# Silicon Anomaly Sheet

**AD1837**

This document details known bugs in the current version of the AD1837.

Figure 4. Reset Synchronized to Rising Edge of FSTDM/ALRCLK

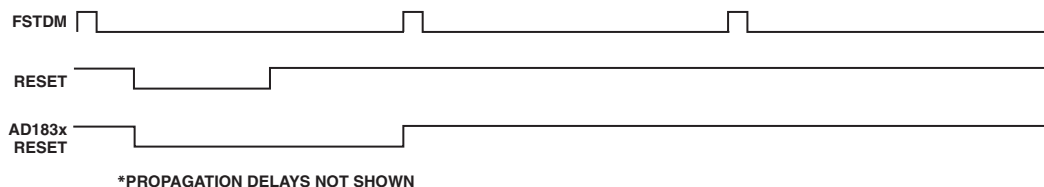
The ADC engine used in the AD1837 loads the serial port with the results of the last conversion periodically at the sample rate. The loading operation is initially determined by where the  $\overline{\text{PD}}/\overline{\text{RST}}$  pin goes high. For slave mode operation, the LRCLK or FSTDM signal have no fixed relationship so it is possible that the loading operation can occur in the middle of a data transfer. This results in the right ADC sample being one sample ahead of the left ADC sample, which presents itself as a phase shift. See Figure 1.

Synchronizing the rising edge of  $\overline{\text{PD}}/\overline{\text{RST}}$  with the appropriate LRCLK (for I<sup>2</sup>S, left or right justified modes) or FSTDM (for TDM256 mode) edge will ensure that the ADC result updates occur in a safe region and the phase shift will not occur. Figure 2 shows a synchronization circuit using a single flip-flop that latches the reset signal on the rising edge of FSTDM/ALRCLK. Figure 3 shows an alternate circuit for latching the reset on the falling edge of ALRCLK. Figure 4 shows a timing diagram associated with Figure 2. Table I lists the ADC modes affected by this issue and which circuit should be used to prevent it occurring.

ADC Mode	Safe Region	Recommended Circuit
I <sup>2</sup> S	On rising edge of ALRCLK	Figure 2
Left Justified	On falling edge of ALRCLK	Figure 3
Right Justified	On rising edge of ALRCLK	Figure 2
TDM256	On rising edge of FSTDm	Figure 2
